Change Order #2
Taylor Road

Project: Taylor Road
Project #: 25-367-05-29
Contract: 25-367-05-29
CSJ: 0921-02-328
Limits: Business 83 to Mile 2(Daffodil Road)

CONSTRUCTION CONTRACT CHANGE ORDER NUMBER: 2

5. New or revised plan sheet(s) are attached and numbered: 49A, 64A, 201A, 202A, 203A, 204A, 220A, 225A, 235A

DN:	CK: DW	DW:	CK: DW	TW:	STATE	PROJECT NO.	HIGHWAY NO.
					6	TX	TAYLOR RD
					STATE DIST. NO.	COUNTY	CONTROL NO.	SECTION NO.	JOB NO.	SHEET NO.
					21	HIDALGO	0921	02	328	49A

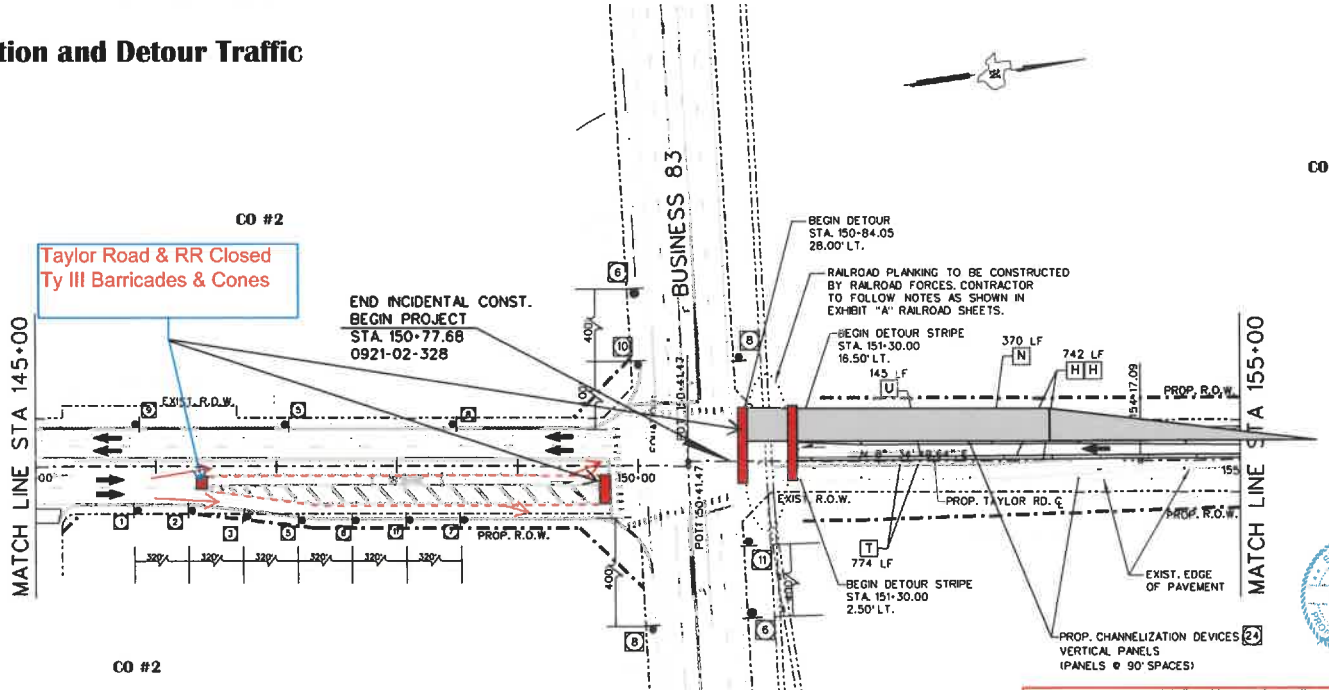
CO #2 - Change Order #2
Phase I, Completely close crossing to reconstruct RR
1.1 - Provided traffic control on the south side of intersection
1.2 - Reopen RR, construct detour, restripe crossing, shift traffic

DIST	STATE	PROJECT NO.			HIGHWAY NO.
CK BY:	6	TX			TAYLOR RD
DW BY:	STATE DIST. NO.	COUNTY	CONTROL NO.	SECTION NO.	JOB NO.	SHEET NO.
CK BY:	21	HIDALGO	0921	02	328	64A
FB:						
CK BY:

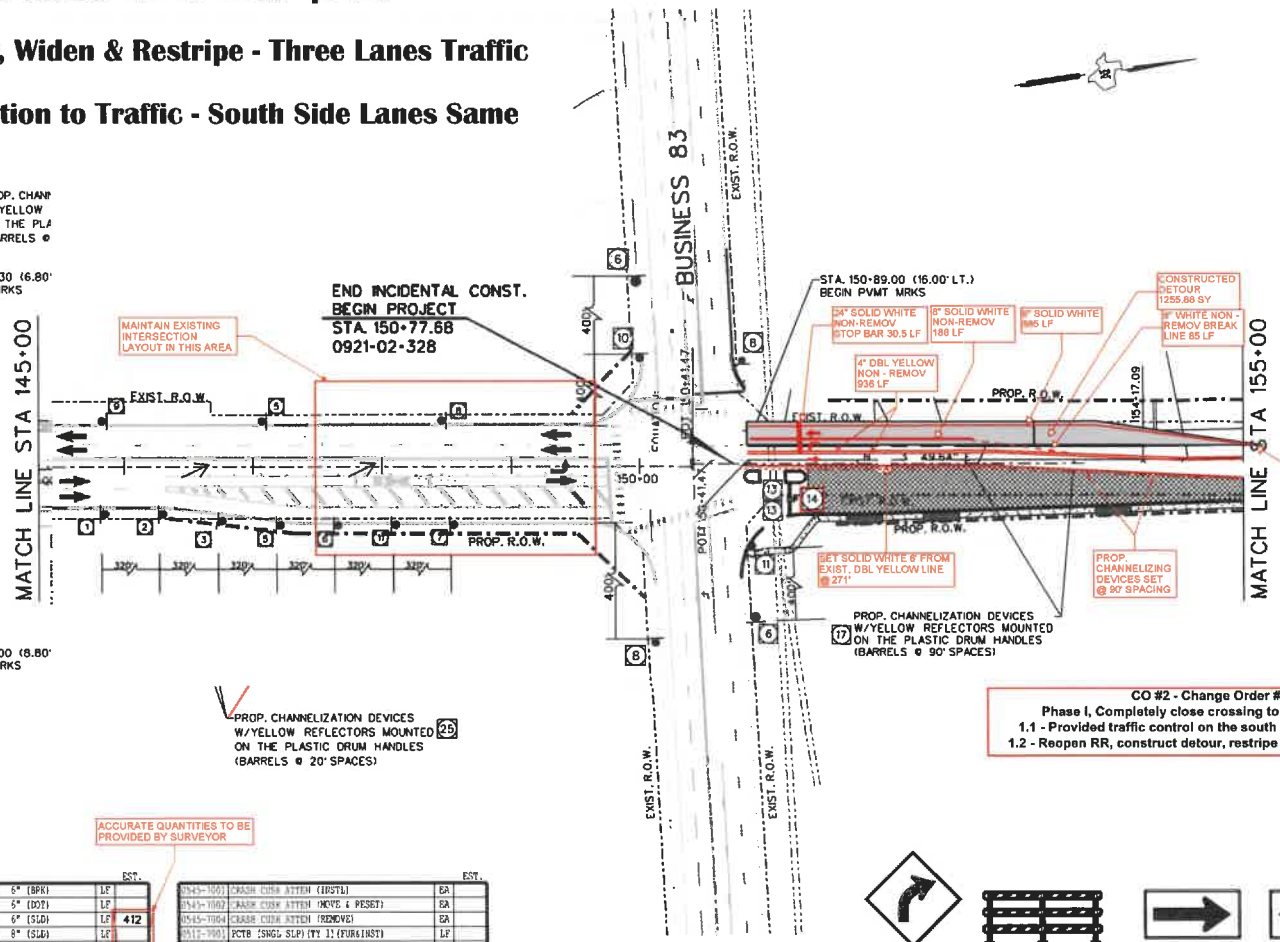
CO #2 - Change Order #2
Phase I, Completely close crossing to reconstruct RR
1.1 - Provided traffic control on the south side of Intersection
1.2 - Reopen RR, construct detour, restripe crossing, shift traffic

SHEET 1 OF 23
DESIGNED: CH
DRAWN: DR
CHECKED: CH
REVIEW: CH
STATE: TX
PROJECT NO.
TAYLOR
COUNTY: HIDALGO
CONTROL NO.: 0921
SECTION NO.: 02
JOB NO.: 328
SHEET NO.: 201A
R:\2025\02-Mission\Taylor Rd_Nor th\DGN\PlanSheets\041AYLOR_U001.dgn
10/16/2024

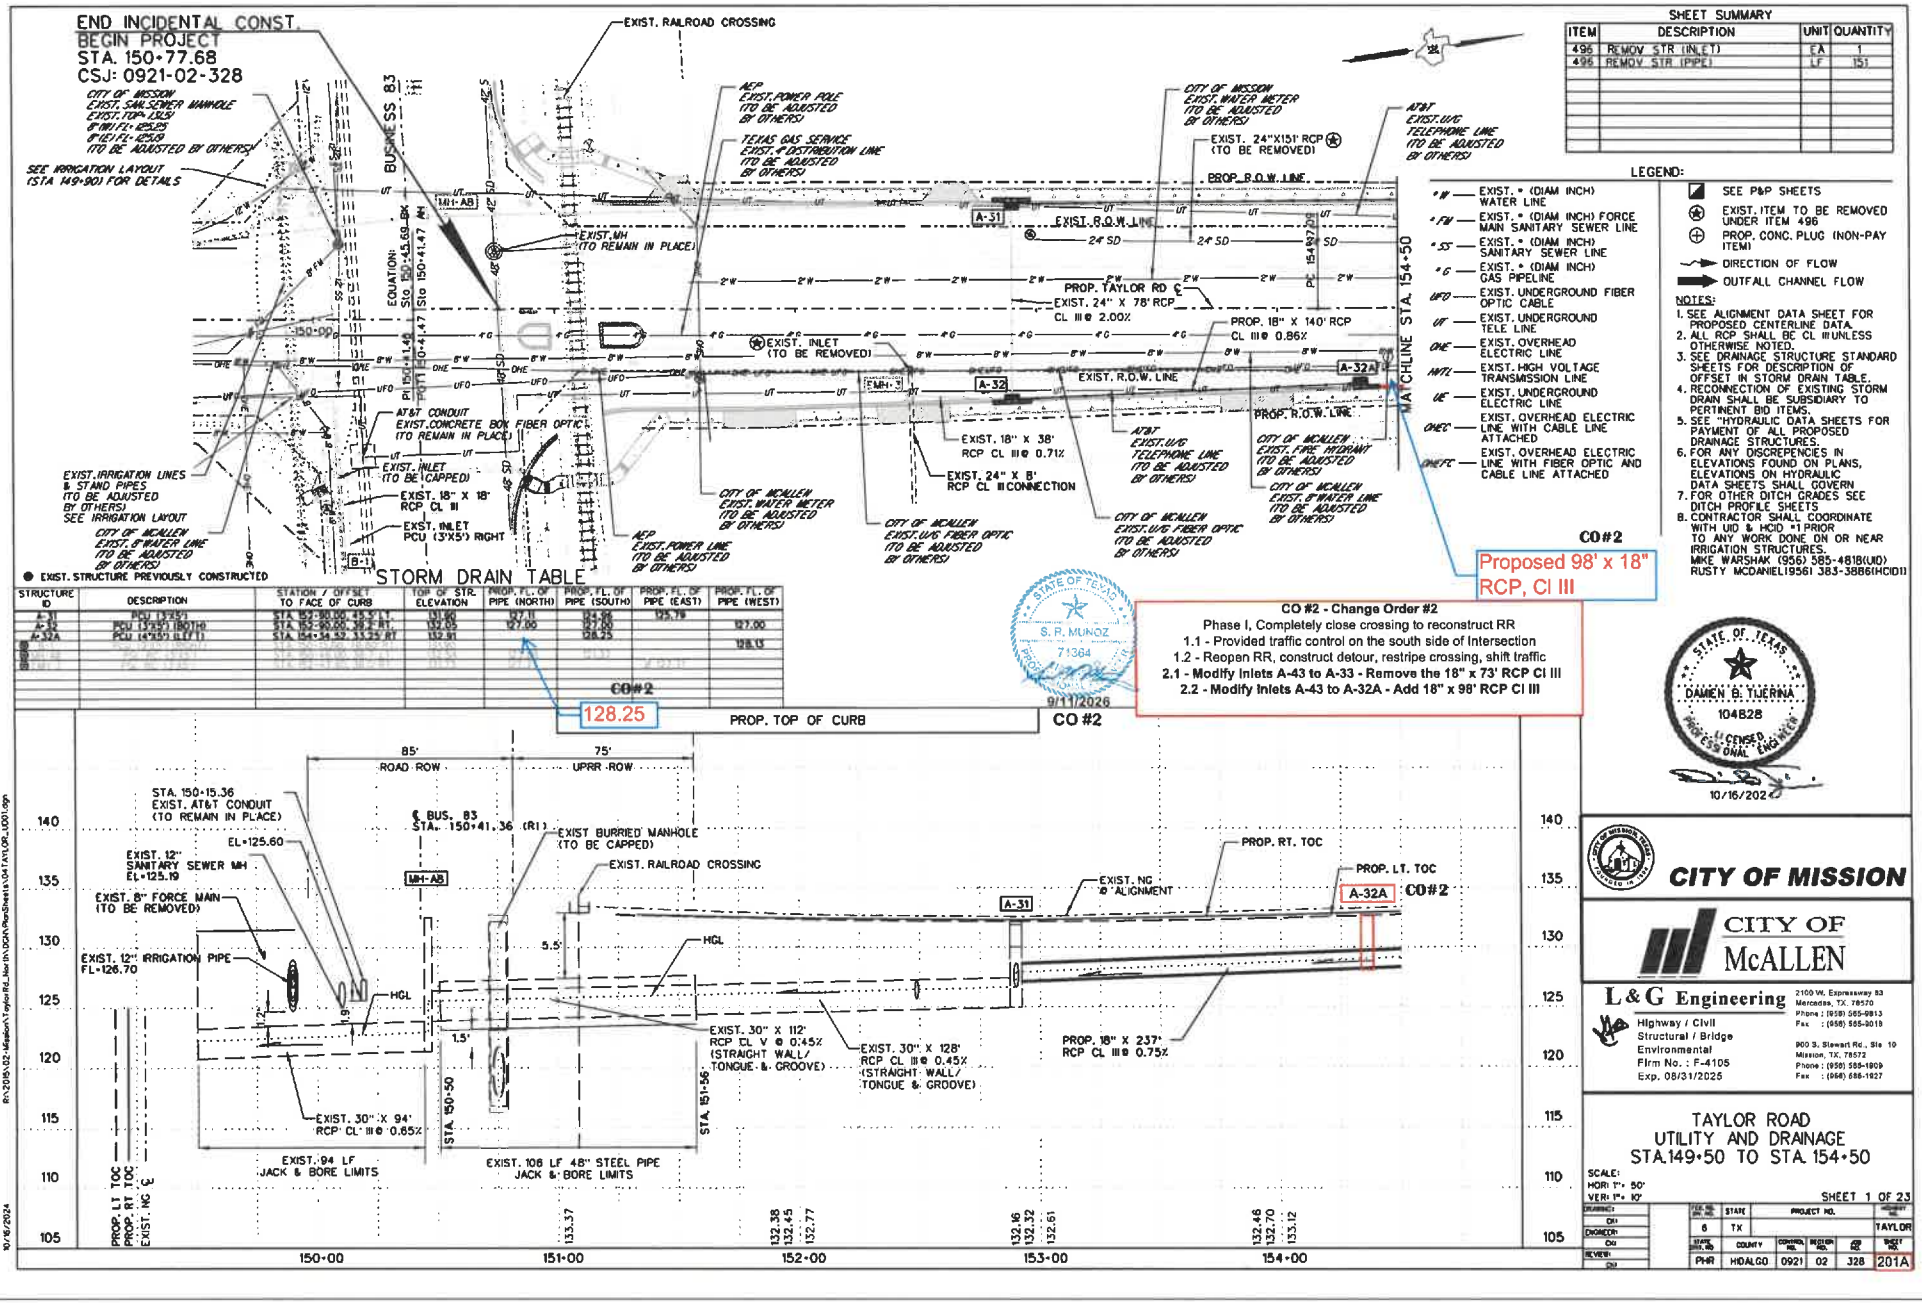
1.2 - Reopen RR, construct detour, restripe crossing, shift traffic
2.1 - Modify Inlets A-43 to A-33 - Remove the 18" x 73' RCP CI III
2.2 - Modify Inlets A-43 to A-32A - Add 18" x 98' RCP CI III
STATE OF TEXAS S. R. MUNOZ 71364 PROFESSIONAL ENGINEER 9/11/2026
STATE OF TEXAS DAMEN B. TIJERINA 104828 LICENSED PROFESSIONAL ENGINEER 10/16/202

CO#2
Do Not Install
18" x 73' RCP Cl III
Not Required

CO#2
Proposed
18" Cl III x 98' RCP @
0.69%

DRAWN BY:	CK:	ENGINEER:	CK:	REVIEW:	CK:	FED. RD. DIV. NO.	STATE	PROJECT NO.				HIGHWAY NO.
						6	TX					TAYLOR
						STATE DIST. NO.	COUNTY	CONTROL NO.	SECTION NO.	JOB NO.		SHEET NO.
						PHR	HIDALGO	0921	02	328		202A

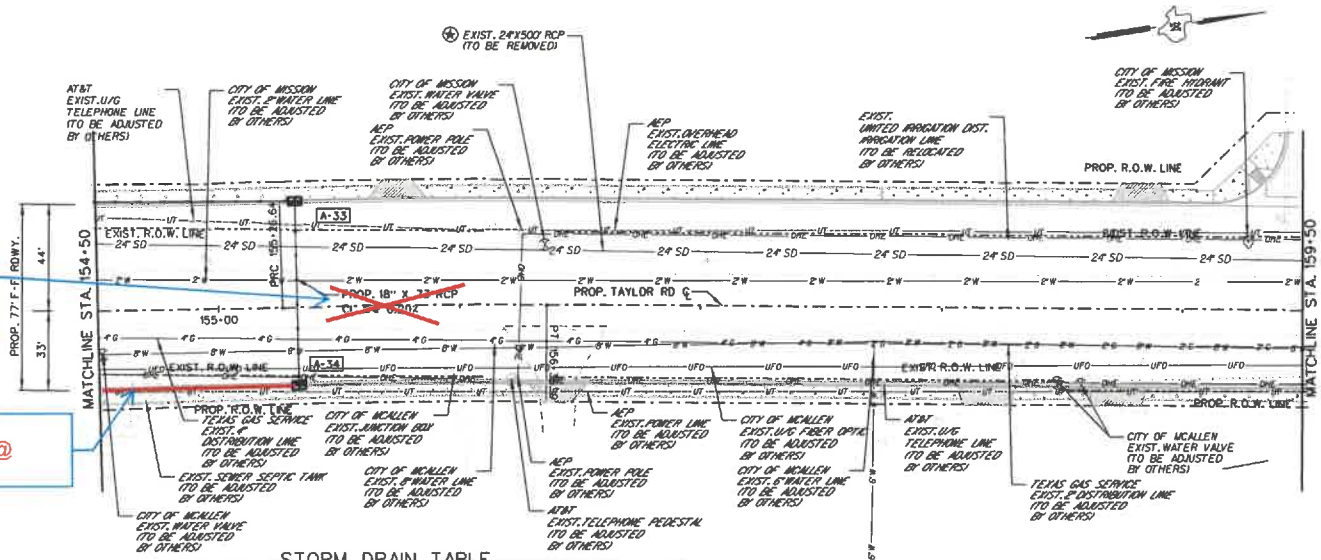
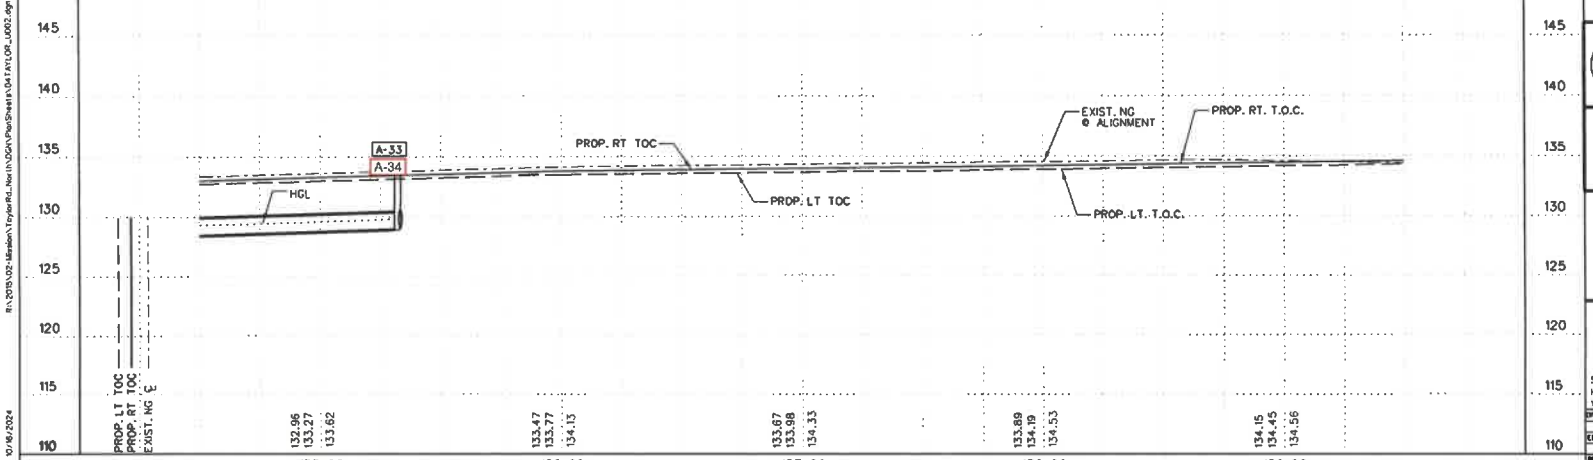
CO #2 - Change Order #2
Phase I, Completely close crossing to reconstruct RR
1.1 - Provided traffic control on the south side of intersection
1.2 - Reopen RR, construct detour, restripe crossing, shift traffic
2.1 - Modify Inlets A-43 to A-33 - Remove the 18" x 73' RCP Cl III
2.2 - Modify Inlets A-43 to A-32A - Add 18" x 98' RCP Cl III

FED. RDS. DIST. NO.	STATE	PROJECT NO.			HIGHWAY NO.
6	TX				TAYLOR
STATE DIST. NO.	COUNTY	CONTROL NO.	SECTION NO.	JOB NO.	SHEET NO.
PHR	HIDALGO	0921	02	328	203A

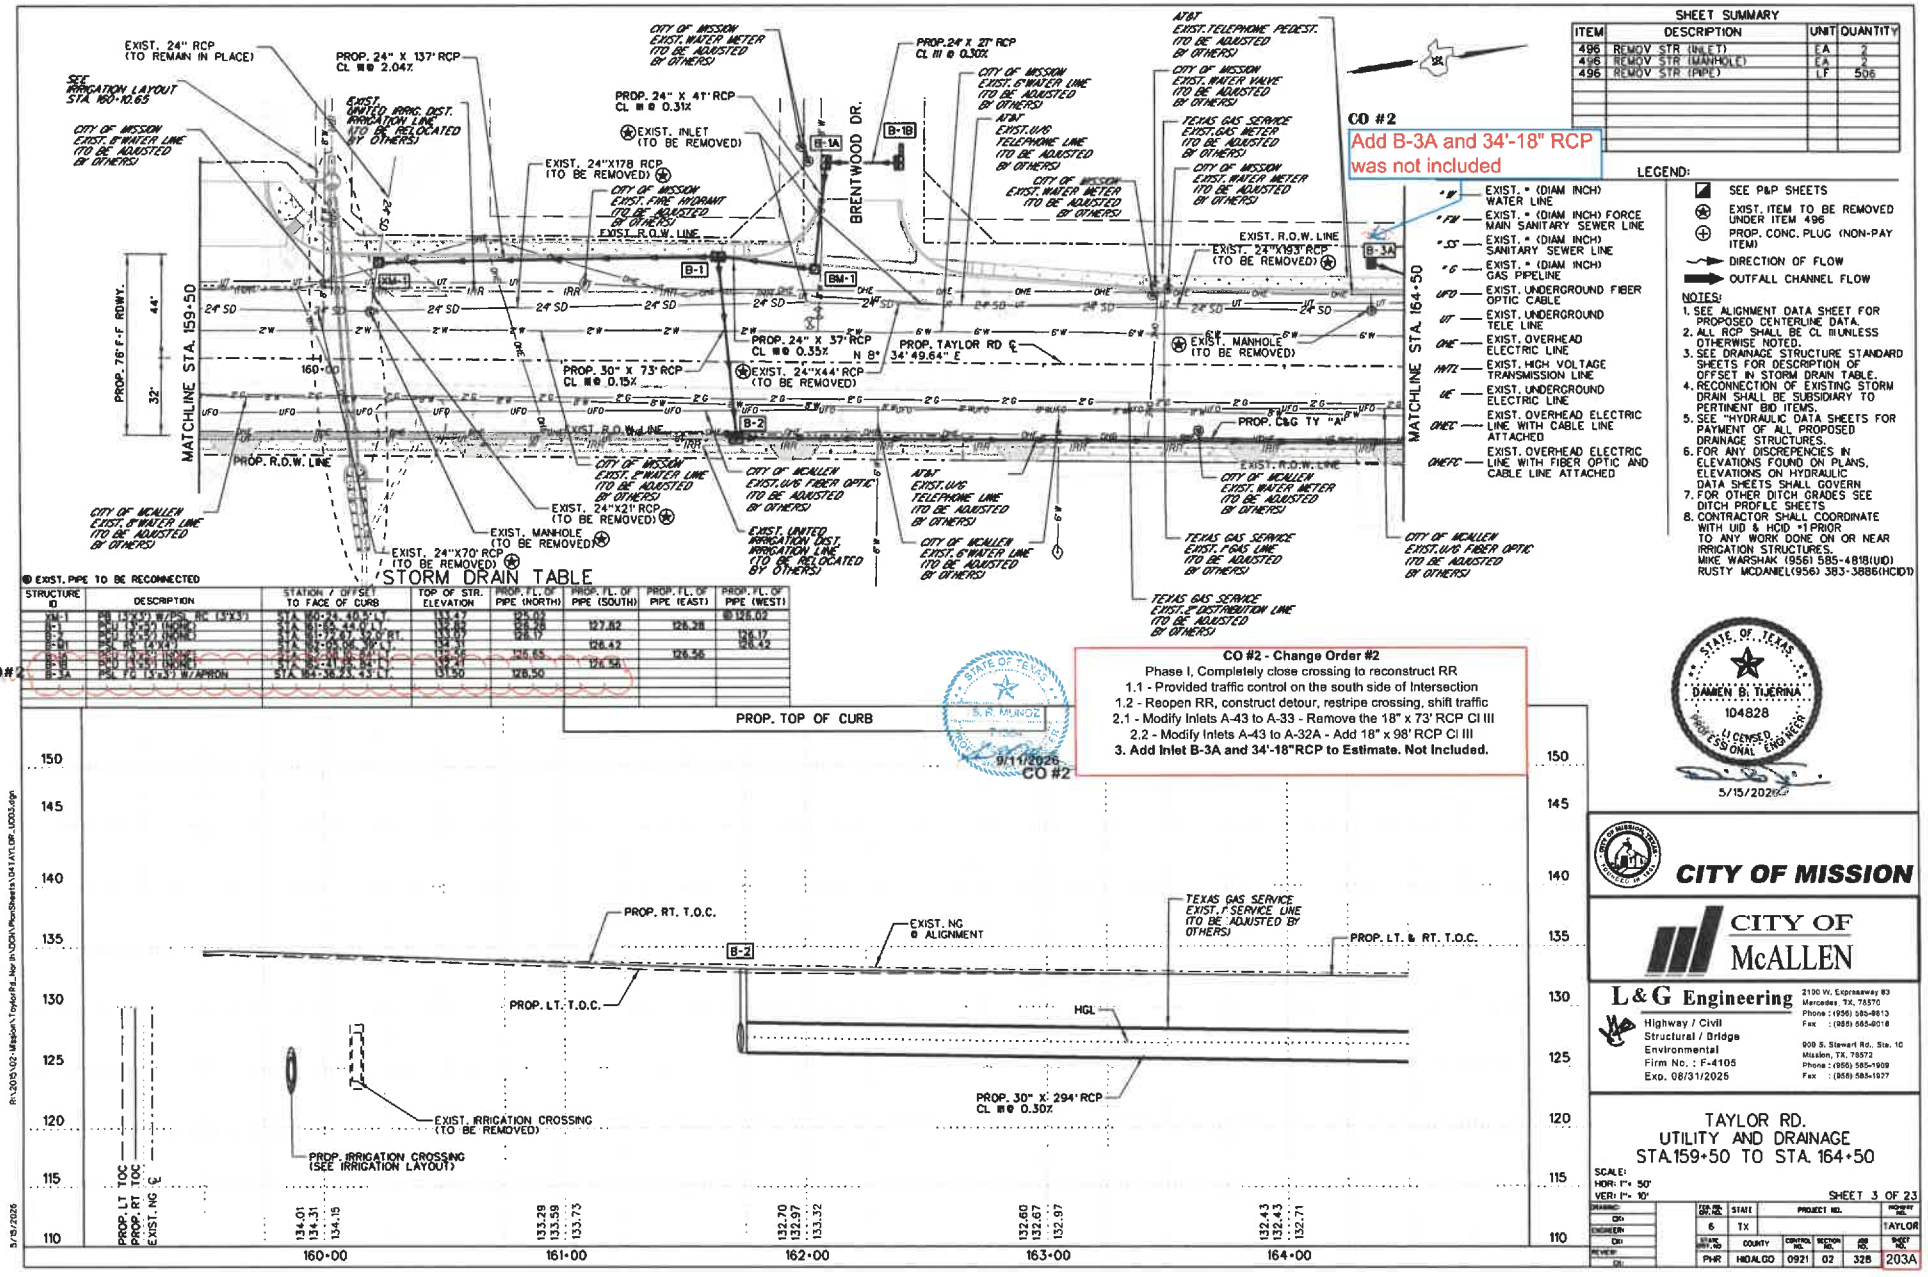
CO #2 - Change Order #2
Phase I, Completely close crossing to reconstruct RR
1.1 - Provided traffic control on the south side of Intersection
1.2 - Reopen RR, construct detour, restripe crossing, shift traffic
2.1 - Modify Inlets A-43 to A-33 - Remove the 18" x 73' RCP Cl III
2.2 - Modify Inlets A-43 to A-32A - Add 18" x 98' RCP Cl III
3. Add Inlet B-3A and 34'-18"RCP to Estimate. Not Included.

DATE: 5/23/2025	CONT	SECT	JOB	HIGHWAY
DN:	921	02	328	TAYLOR
CK DN:	DIST	COUNTY		SHEET NO.
DW:	PHR	HIDALGO		225A
CK DW:

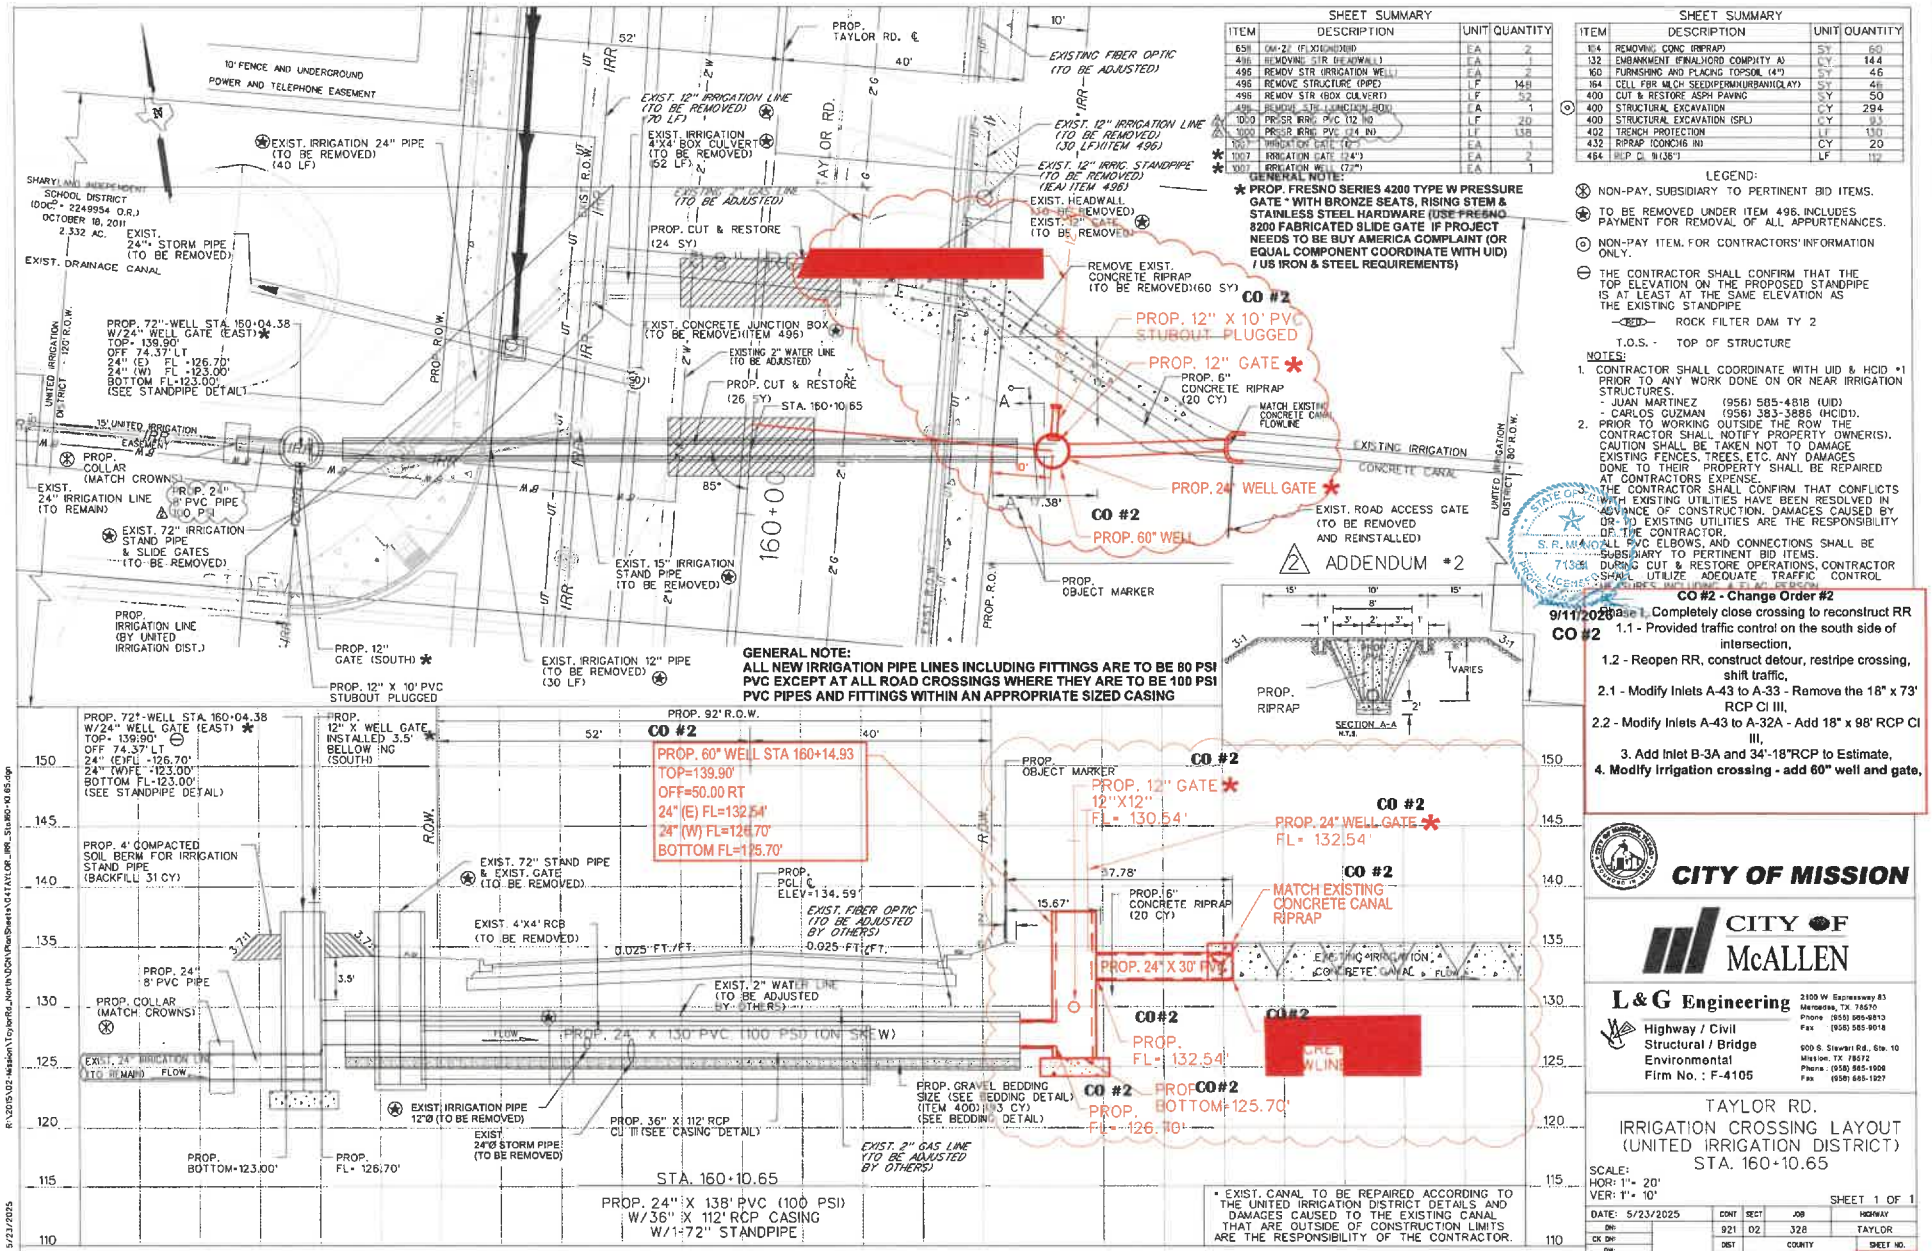
CO #2 - Change Order #2
Base bid
1.1 - Provided traffic control on the south side of intersection,
1.2 - Reopen RR, construct detour, restripe crossing, shift traffic,
2.1 - Modify Inlets A-43 to A-33 - Remove the 18" x 73' RCP Cl III,
2.2 - Modify Inlets A-43 to A-32A - Add 18" x 98' RCP Cl III,
3. Add Inlet B-3A and 34'-18"RCP to Estimate,
4. Modify Irrigation crossing - add 60" well and gate,
